EASA Safety Information Bulletin

SIB No.: 2014-34
Issued: 23 December 2014

Subject: **Possible Exceedance of Engine Temperature Limits of BRP-Powertrain Rotax 912 and 914 Engines**

Ref. Publication: BRP Powertrain Service Bulletin SB-912-066 and SB-914-047 (single document) dated 08 December 2014, or later approved revisions.

Picture 1 – CHT versus CT measurement

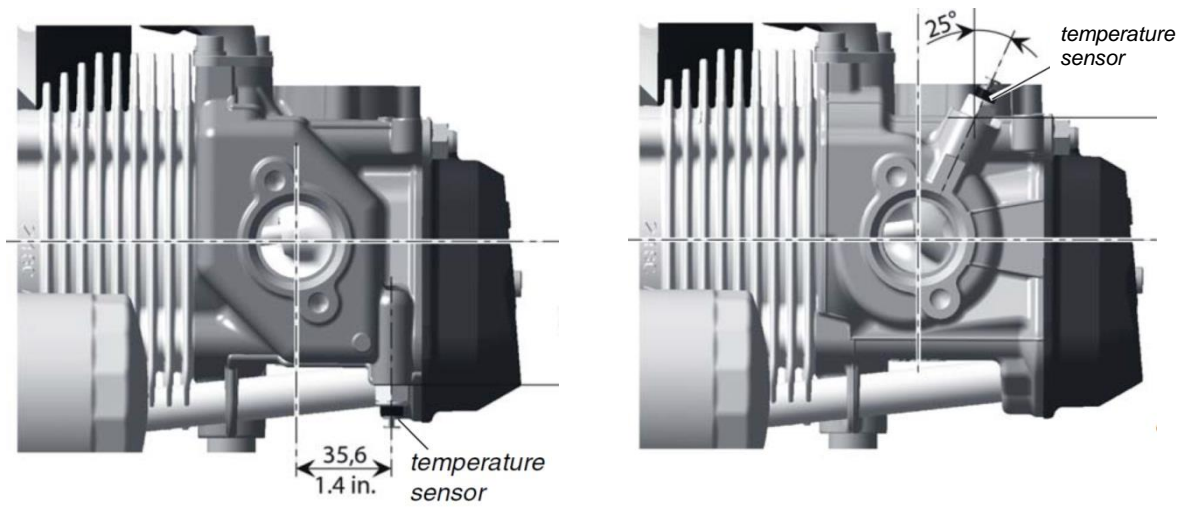
The reported conditions are the result of an insufficiently communicated engine design change which altered the engine/aircraft interfaces by substituting the previous cylinder head temperature (CHT) measurement (limit temperature 135°C/150°C) with a coolant temperature (CT) measurement (limit temperature 120°C).

This design change is currently not identified by the engine model designation or the engine P/N but only through the cylinder head P/N and the position of the temperature sensor:

CHT measurement → temperature sensor points downward
 CT measurement → temperature sensor points upward

Refer to [Picture 1](#) in Annex 1 of this SIB.

- Identify if affected engines or cylinder heads, as specified in BRP SB 912-066/SB 914-047, have been installed on an aircraft during production since January 2013.
- Verify if the approved engine installation and the approved aircraft limitations are adequate to incorporate CT measurement instead of the previous design CHT measurement.
- Inform aircraft operators via the TC/STC holder publication system which actions, if any, are required to restore an approved design and to ensure a safe aircraft operation, or if no actions are required.

- Identify if affected engines or cylinder heads, as specified in BRP SB 912-066/SB 914-047, have been installed on an aircraft during production or maintenance since January 2013. This can be done through a review of the aircraft

records or through a visual inspection of the cylinder head design (refer to [Picture 1](#) in Annex 1 of this SIB).
